FCC Class II Permissive Change Application Letter

Product name : Mobile Phone
FCC ID: 2BH83-HERO
Date of Grant: 09/02/2024
Model No.: HERO

Change Contents: update the components on main board as below:

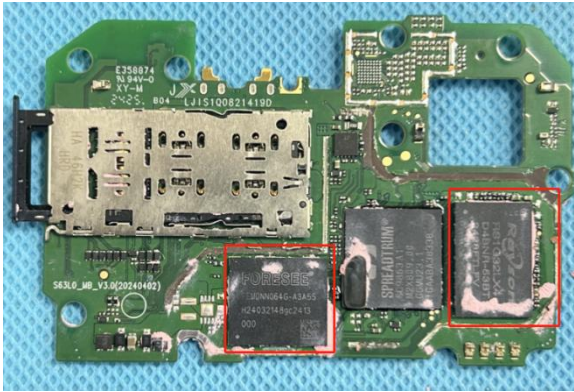
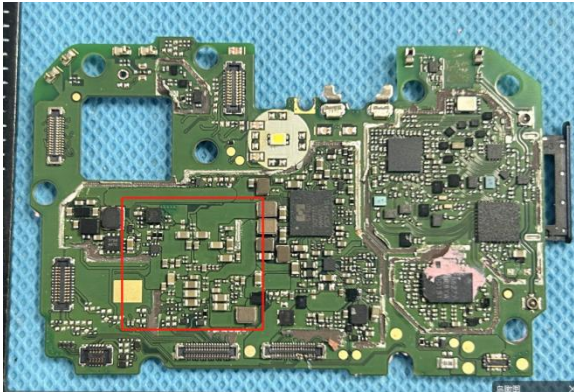
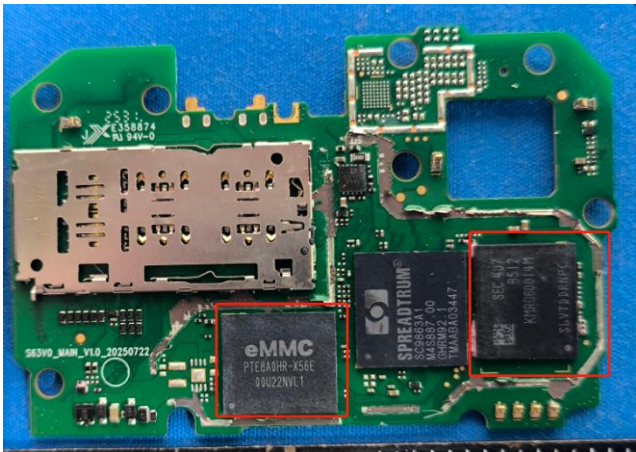
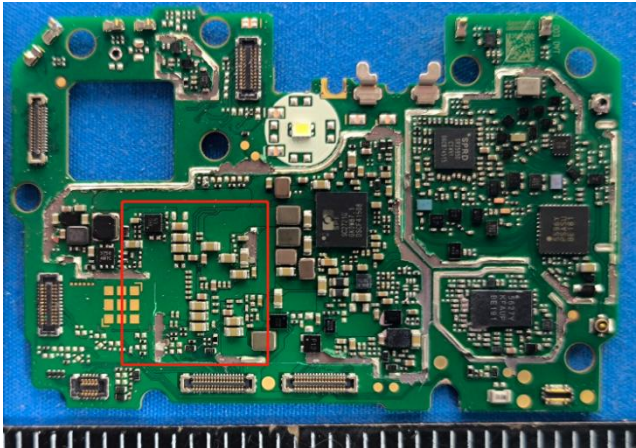
Location	Old PCB of FCC ID: 2BH83-HERO	New PCB of FCC ID: 2BH83-HERO
Main board	<div></div>	<div></div>
DDR model has been changed. The memory package has become larger. Previously it was LPDDR4, now it has been modified to the EMCP format. The PCB model (labeled) has also been changed simultaneously.
